## REVISED RESPONSE TO REQUEST FOR ADDITIONAL INFORMATION

### APR1400 Design Certification

Docket No. 52-046

RAI No.: 252-8299  
SRP Section: 03.07.02 – Seismic System Analysis  
Application Section: 3.7.2  
Date of RAI Issue: 10/19/2015

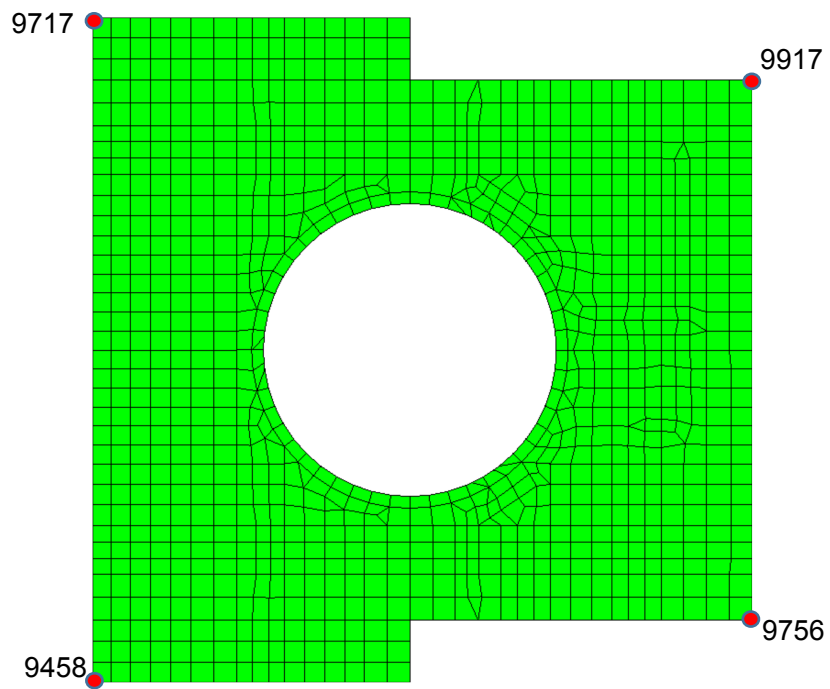
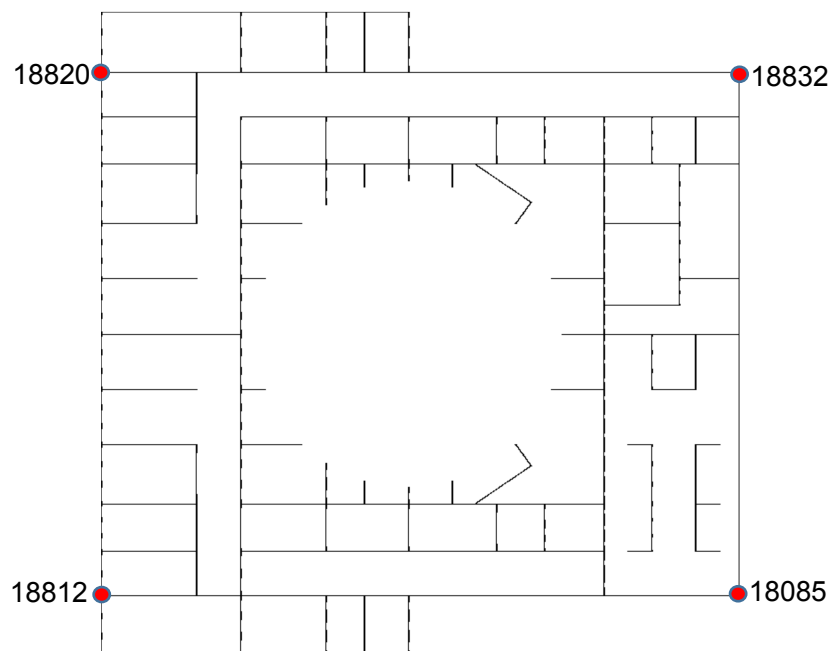
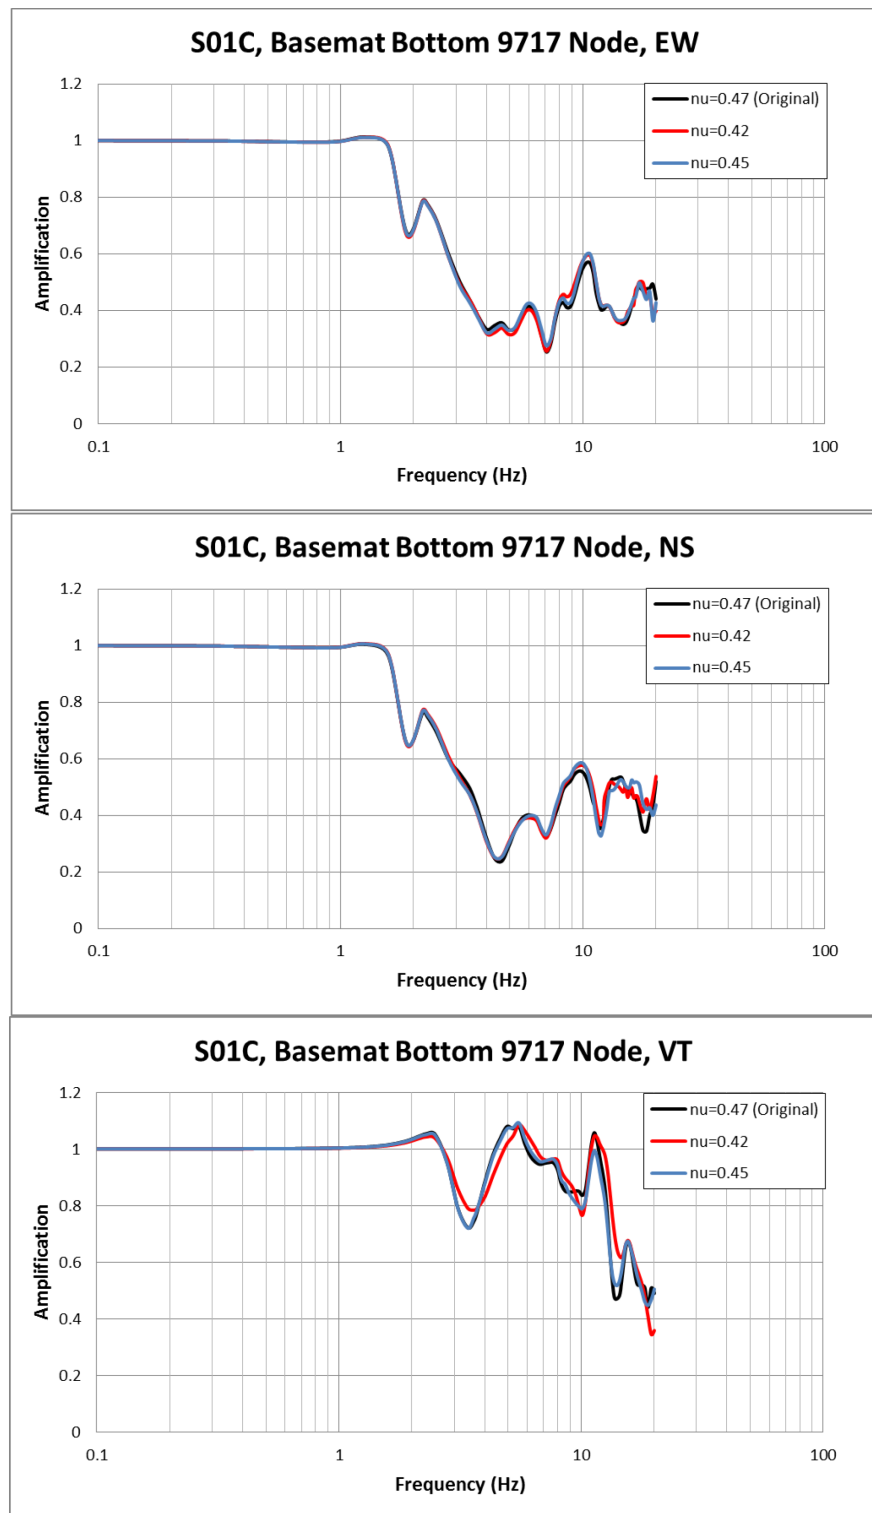
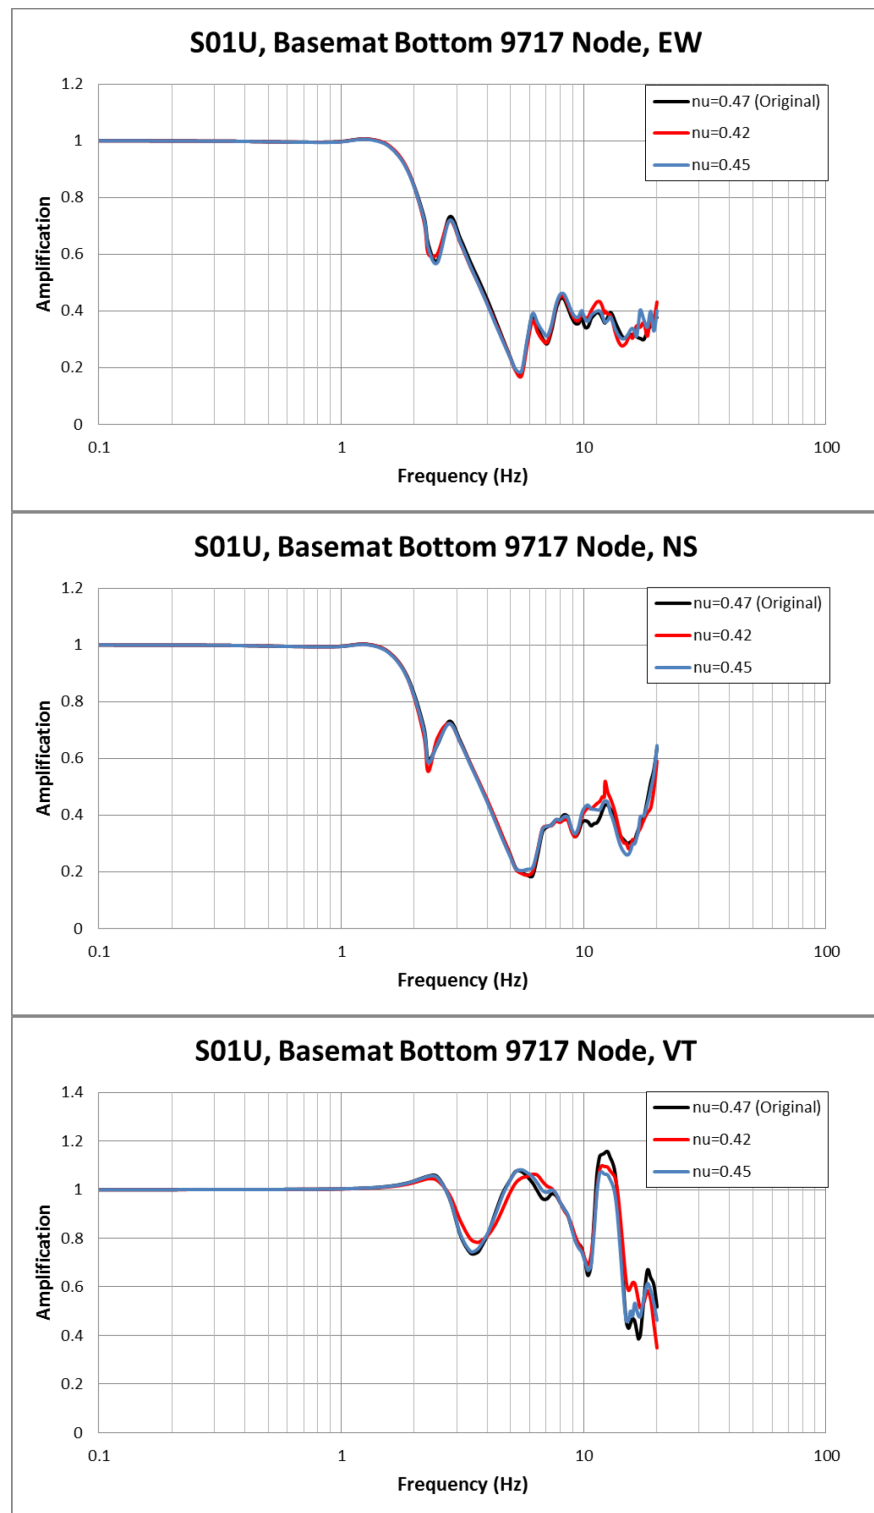
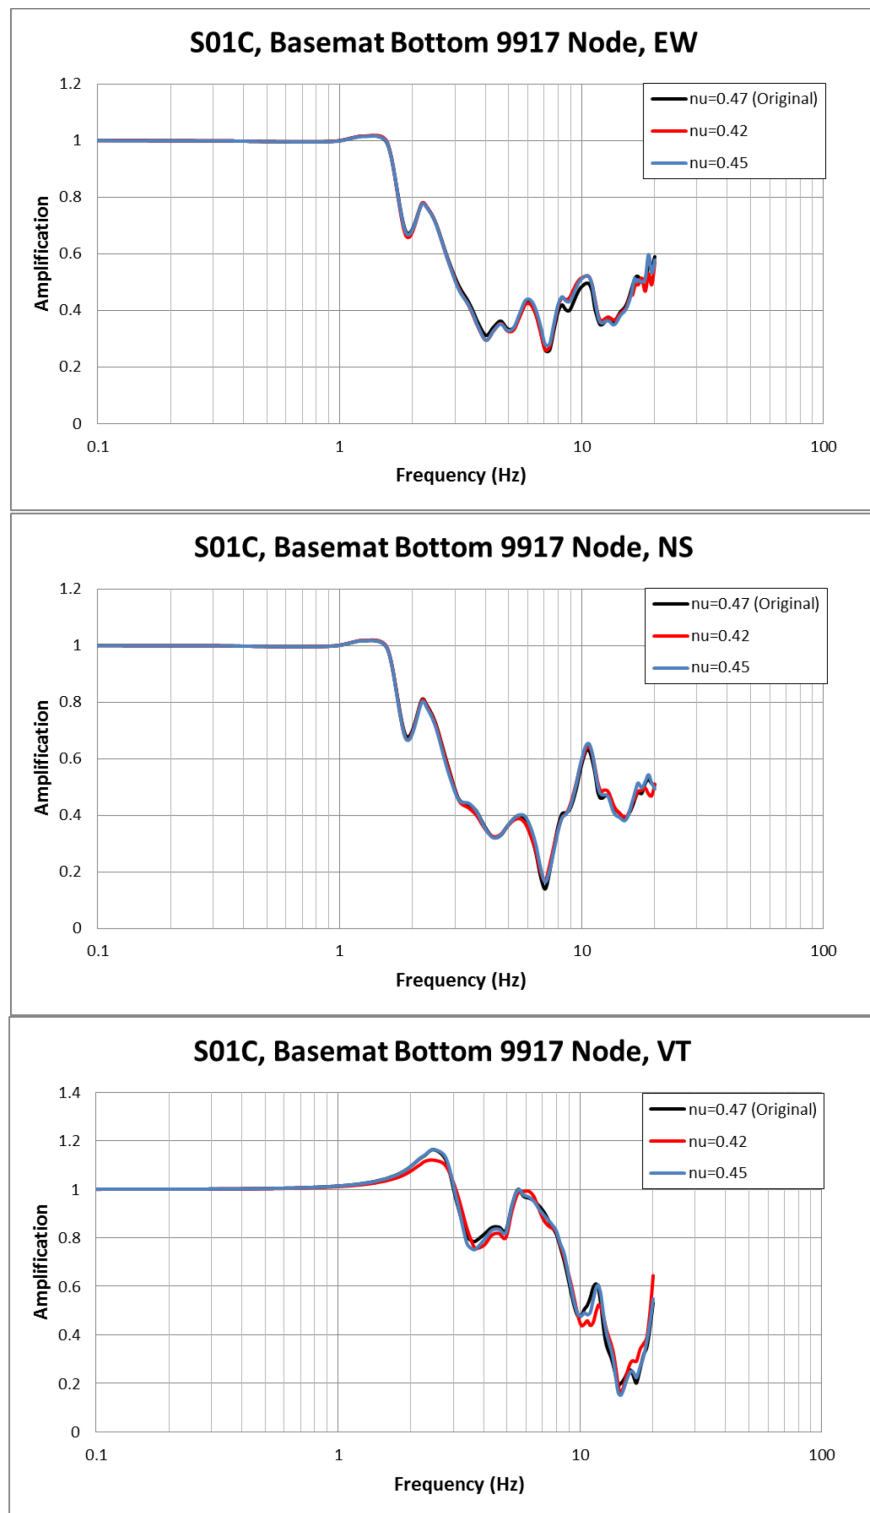
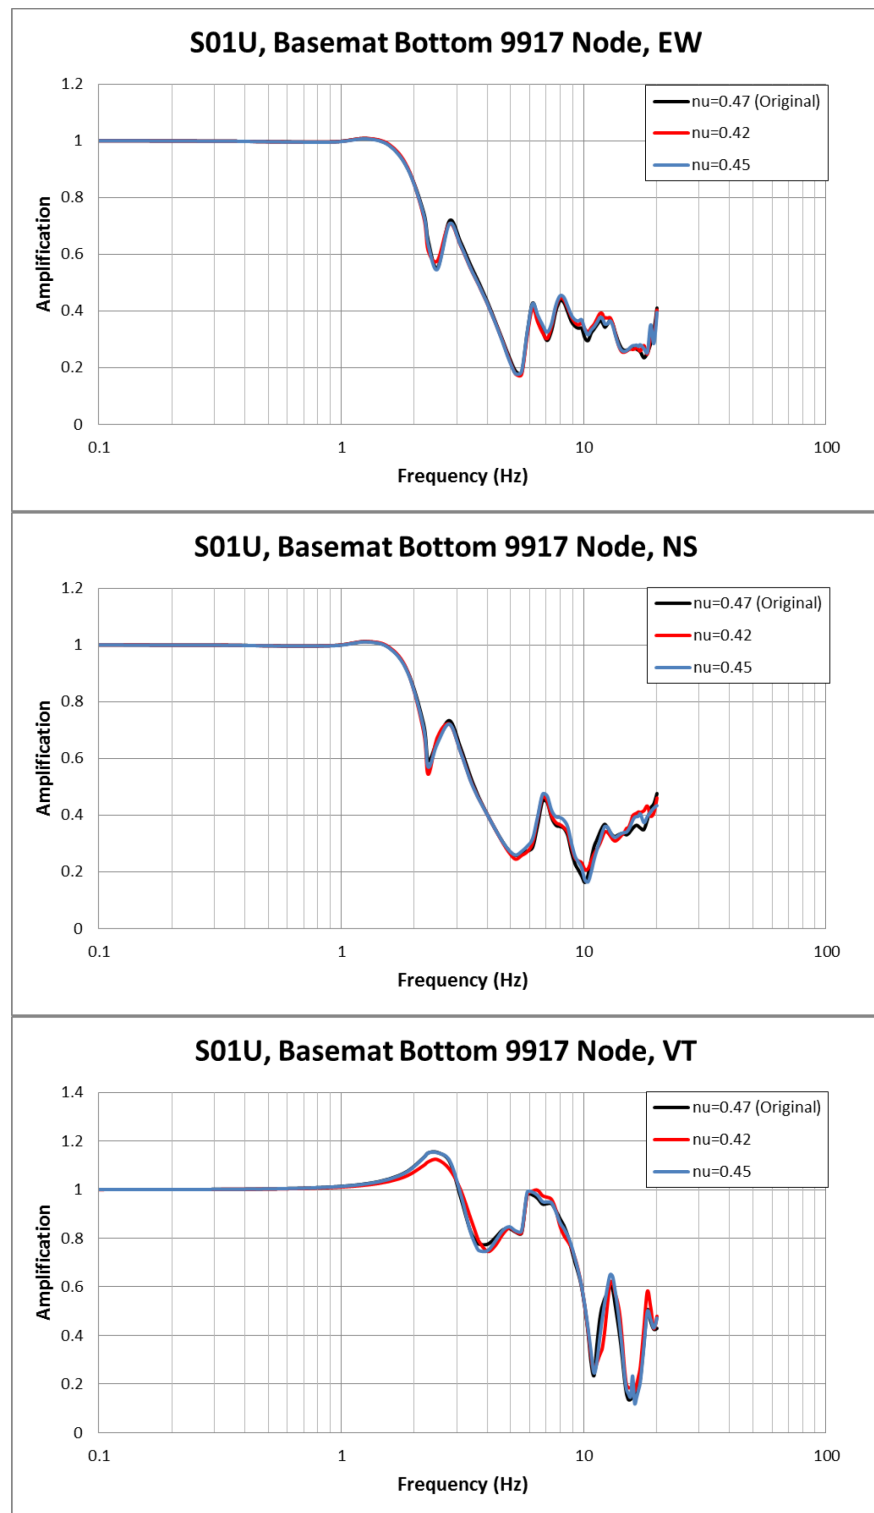
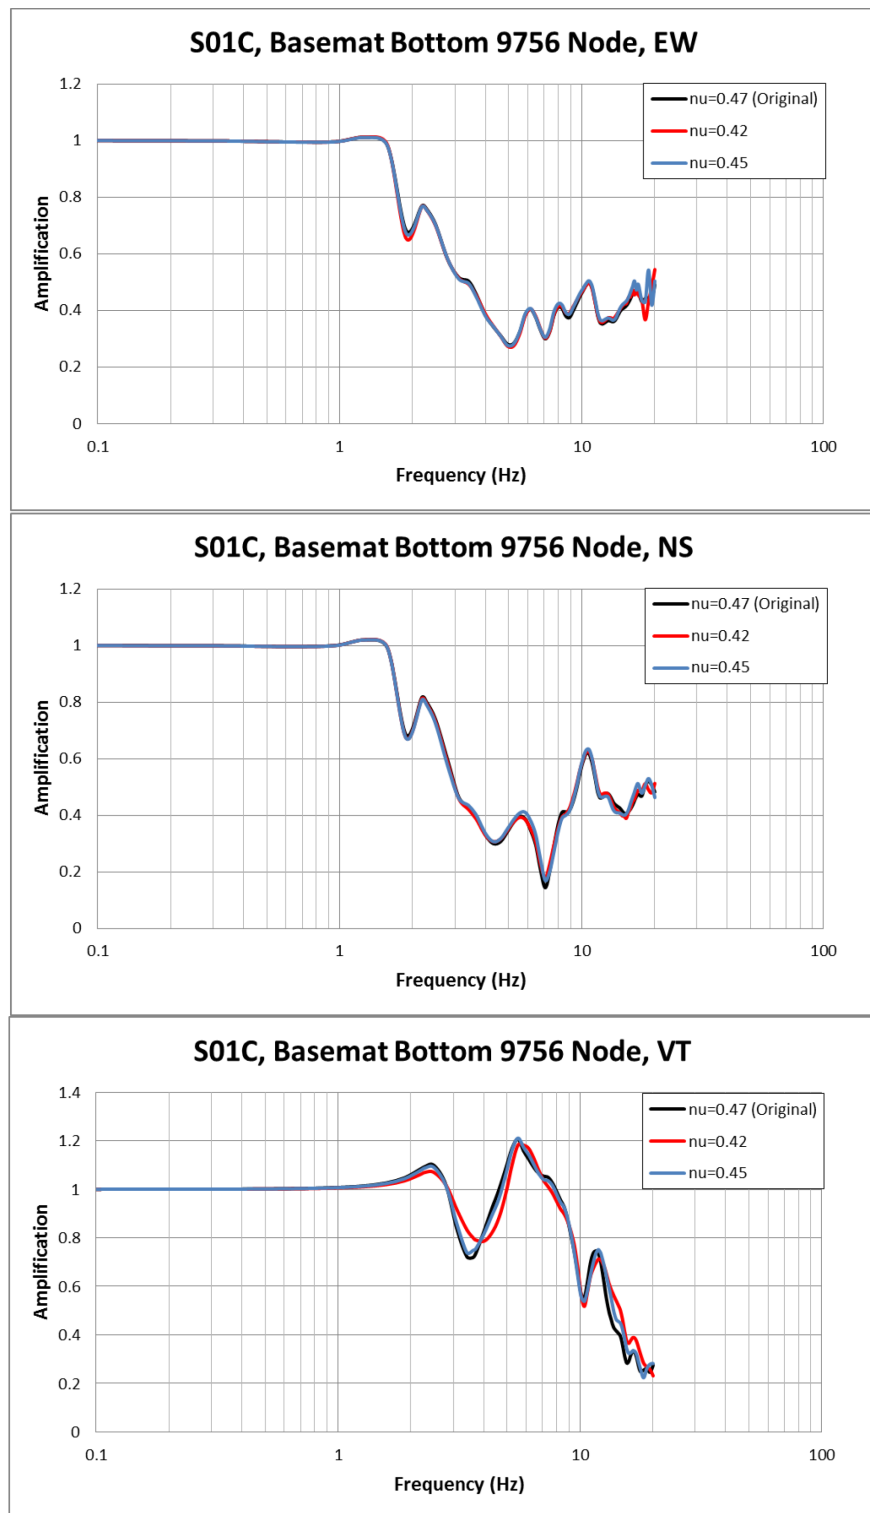
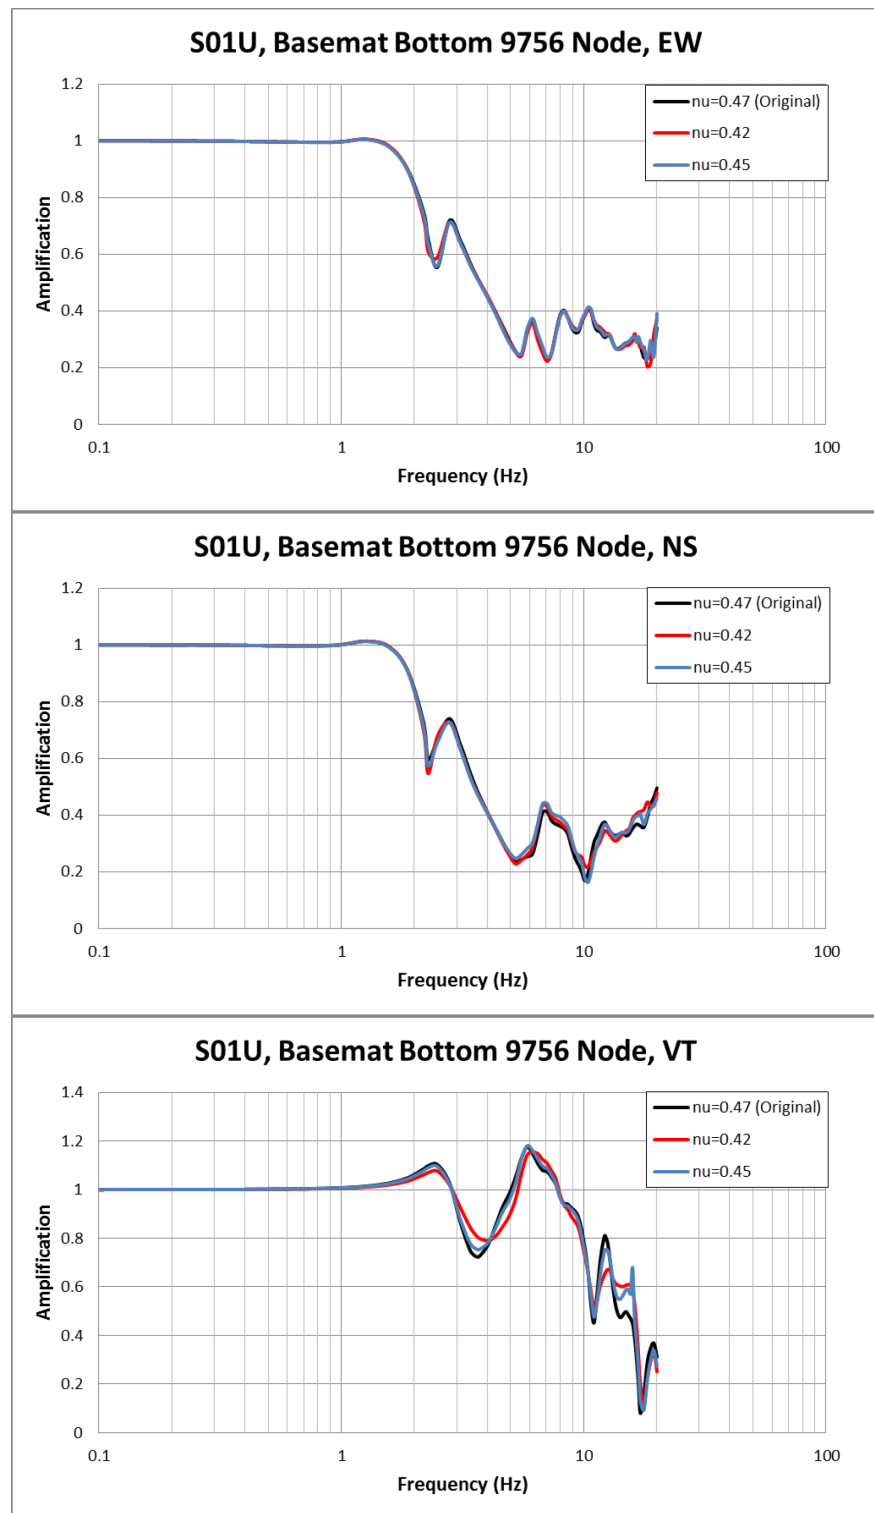
DCD Tables 3.7A-1 and 3.7A-2 show Poisson's ratios in the S1 and S2 soil profiles used for SSI analysis as great as 0.47 and 0.48 respectively. Based on staff experience, use of Poisson's ratio approaching these values may result in numerical instability of the SSI analysis results. Therefore, to assist the staff in evaluating the adequacy of the SSI analysis results based on the aforementioned soil profiles, the staff request the applicant to provide a demonstration (e.g. sensitivity study) that the assumed Poisson's ratio values do not produce numerical instabilities in the SSI results based on these profiles.

- e) It is generally known that a dynamic Poisson's ratio value approaching 0.5 will cause numerical sensitivity problems in SSI analyses using the SASSI program. In the SSI analysis of the APR1400, the dynamic Poisson's ratio of the soil is limited to not greater than 0.48 in order to avoid numerical sensitivity problems. To demonstrate that the Poisson's ratio values used in the SSI analyses of S1 and S2 soil profile cases do not produce numerical instabilities in the SSI analysis results, a sensitivity study is performed using the ACS SASSI Nuclear Island (NI) model of APR1400 with S1 and S2 soil profiles.

In this sensitivity study, the S1 and S2 soil profiles which have the maximum Poisson's ratio values of 0.47 and 0.48 are modified to have maximum Poisson's ratio values of 0.45 and 0.42. In the sensitivity study, the shear wave (S-wave) and compression wave (P-wave) velocities of the soil layers in the ACS SASSI NI SSI model, which have the Poisson's ratio values greater than the assumed maximum Poisson's ratio values of 0.45 and 0.42, are modified to reduce the Poisson's ratio values of the soil layers. For the horizontal SSI analyses, the compression wave velocities are modified to meet the maximum Poisson's ratio values of 0.45 and 0.42. On the other hand, for the vertical SSI analyses, the shear wave velocities of soils in the SSI models are modified to meet the maximum Poisson's ratio values of 0.45 and 0.42. The modified shear and compression wave velocities of S1 and S2 soil profiles considered in the sensitivity study are presented in Tables 2 through 5.

Using the modified soil profiles of S1 and S2, SSI analyses of NI models of both cracked and uncracked concrete stiffness cases are re-performed. Then, the transfer function results at NI basemat bottom and plant grade elevations obtained from the original SSI analyses and the re-performed SSI analyses in the sensitivity study are compared to judge the existence of numerical instabilities in the original SSI results. The locations of the selected nodes at basemat bottom and plant grade elevations using in the comparisons are provided in Figures 18 and 19. The comparisons of transfer function results for S1 and S2 soil profile cases are presented in Figures 20 through 51.

As shown in the comparisons of transfer functions presented in these figures, the transfer functions obtained from the original SSI analyses are quite similar and comparable to the transfer functions obtained from the sensitivity study re-performed SSI analyses. In addition, no abrupt changes or spurious peaks, which tend to indicate existence of

numerical sensitivities in the SASSI solutions, appear in the computed transfer functions of the original SSI analyses that have the maximum dynamic Poisson's ratio values of 0.47 and 0.48 as well as in the re-computed transfer functions that have the maximum dynamic Poisson's ratio values limited to 0.42 and 0.45. These results demonstrate that there is no numerical instabilities in the original SSI analysis results of the S1 and S2 soil profile cases.

**Figure 3-21 Connection between RCS Supports and Solid Elements**

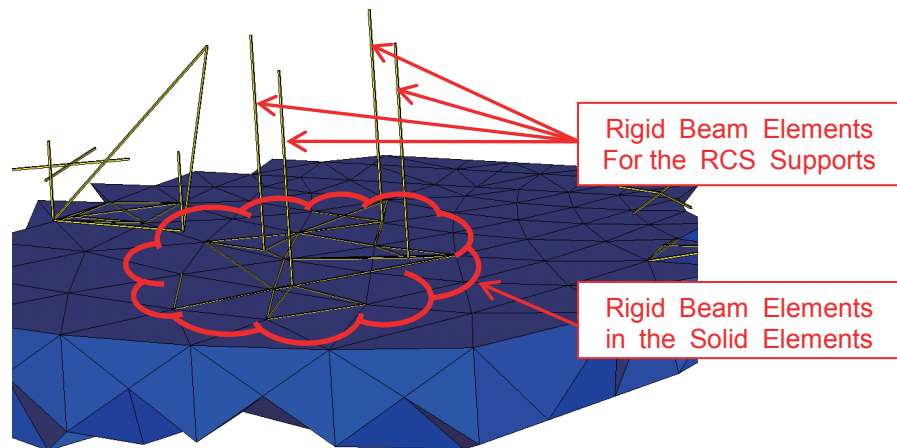
Staff review of APR1400-E-S-NR-14002-P finds that the nuclear island finite element model includes locations at which beam elements connect with solid elements (e.g. connections between the reactor coolant system model and the containment internal structure model). However, the staff did not find a description of how the degree of freedom compatibility is addressed for transitions between beam and solid elements. Therefore the staff requests the applicant to provide such description, including a graphical representation of the transition between beam and solid elements.

The degrees of freedom compatibility condition between the beam elements of the RCS and solid elements of the PSW and the SSW is satisfied by using rigid beam elements at the beam-to-wall support points covering the footprint of the RCS support brackets. The RCS supports are modeled as rigid beam elements and connected with other rigid beam elements in the solid elements which represent the PSW and the SSW. Figure 3-21 shows the connection between the RCS supports and the solid elements.

Add Figure 3-21 to next page of Figure 3-20.
